MATTIS PROPERTY

ADMINISTRATIVE SITE PLAN AMENDMENT

TECHNICAL DATA SHEET
Petition # 02-101

DATE: June 9, 2003
 TO: Robert Brandon, Zoning Administrator
 FROM: Martin R. Cramton, Jr., Planning Director
 SUBJECT: Administrative Approval for Petition No. 2002-101 by Pulte Homes Corporation.

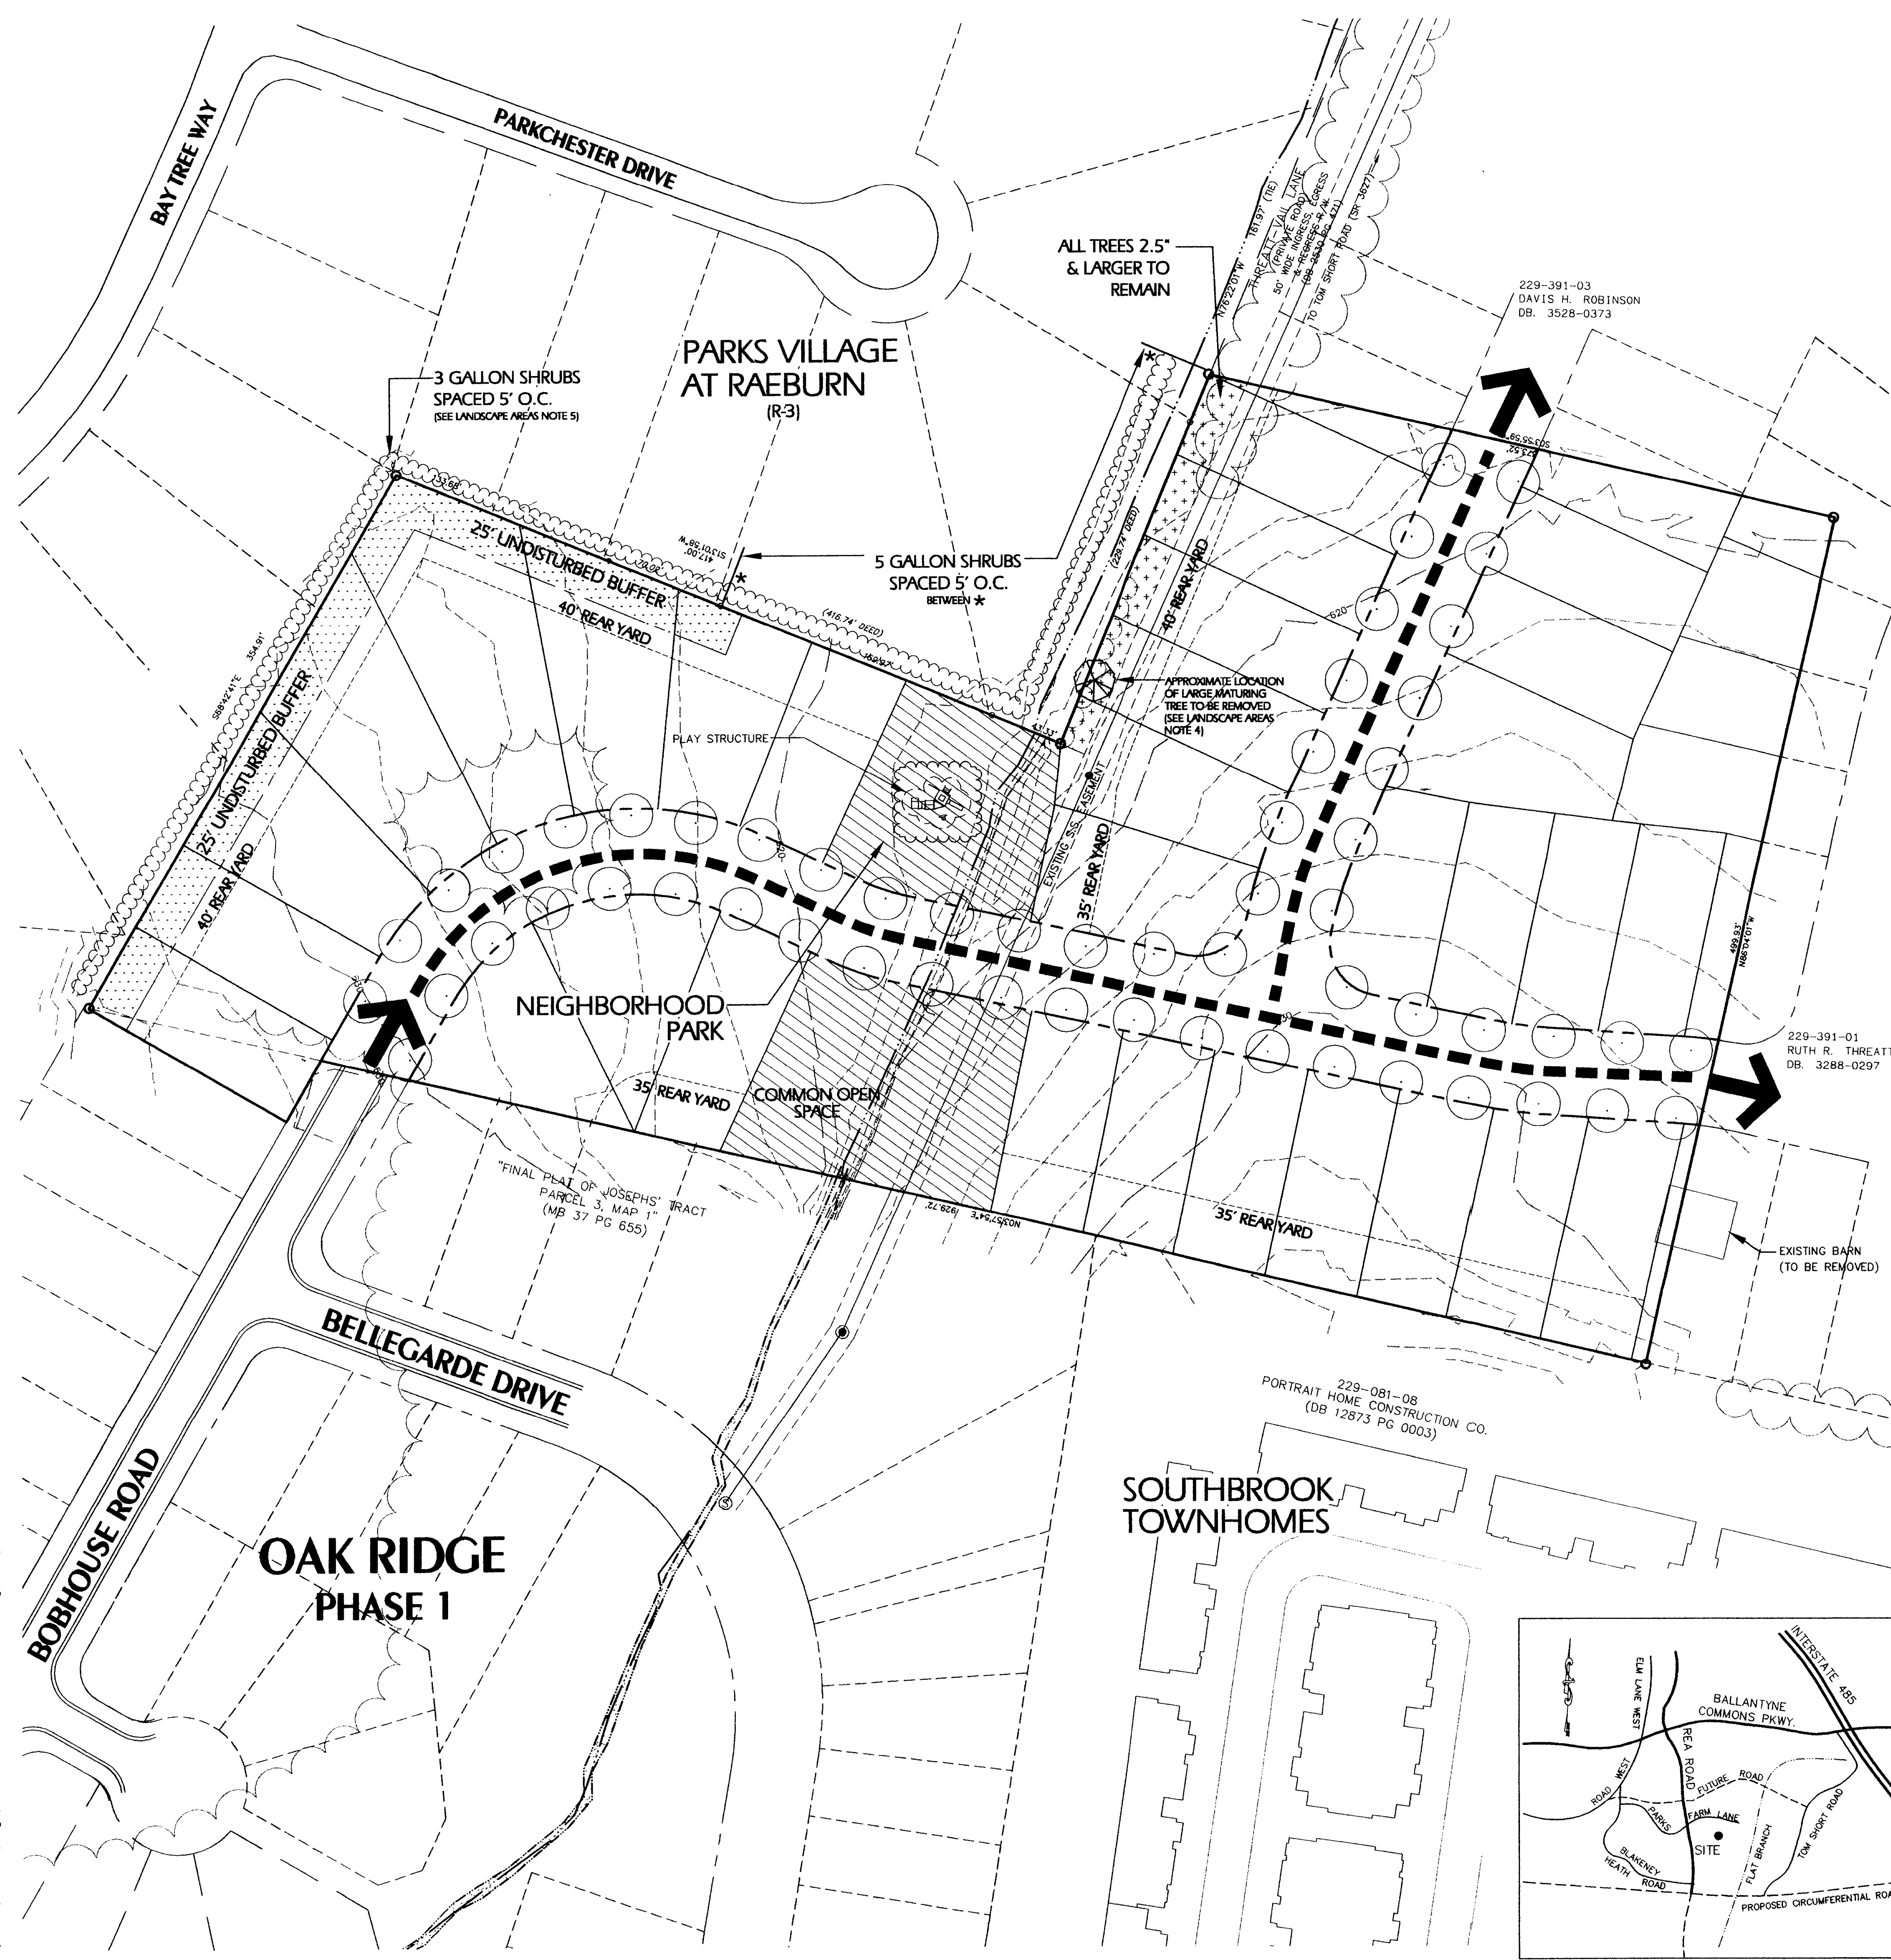
Attached is a revised plan for the above petition. The plan has been revised to change the street alignment and the lot layout along with a reduction of the side yard to three feet except for lots adjoining the Parks Village at Raeburn. Since these changes are minor and do not alter the intent of the development, I am administratively approving this revised plan. Please use this revised plan when evaluating requests for building permits and certificates of occupancy.
